SUNDRY NOTICES AND REPORTS ON WELLS

Poker Lake Unit

Poker Lake Unit #167

☒ Change of Plans

PIERCE CANYON, N. MEX.

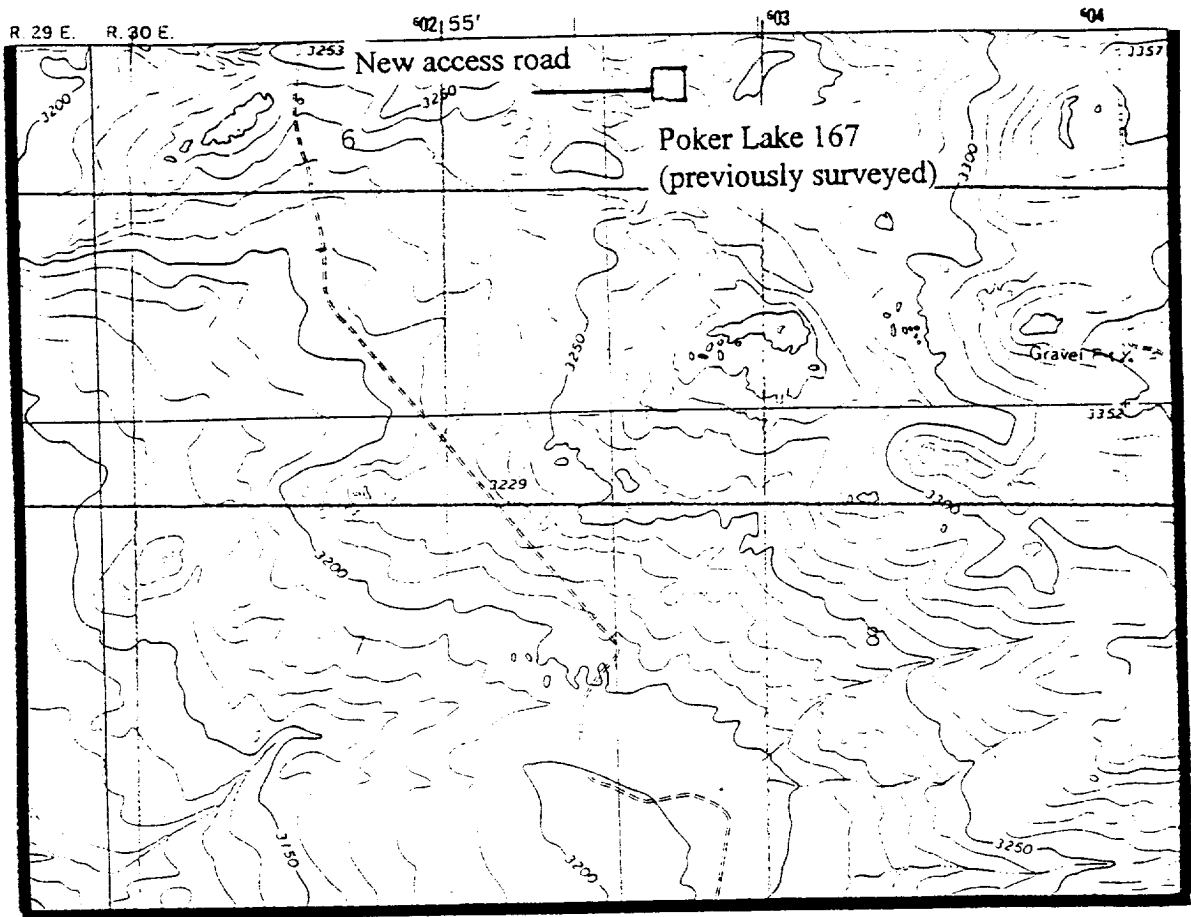
The access road will enter the location from the west per the attached map. The road will be built east from the Poker Lake Unit #152 drill site.

New production facilities will be built on the Poker Lake Unit #153 well pad. The flowline from this well will be layed within 25' of the center line of the access road all the way to the new facility. This is a change in Point 4 (B) of the Multi-Point Surface Use Plan.

Request utility corridor for the electric power lines to follow the access road. The poles and lines will be installed within 25' of the center line of the road.
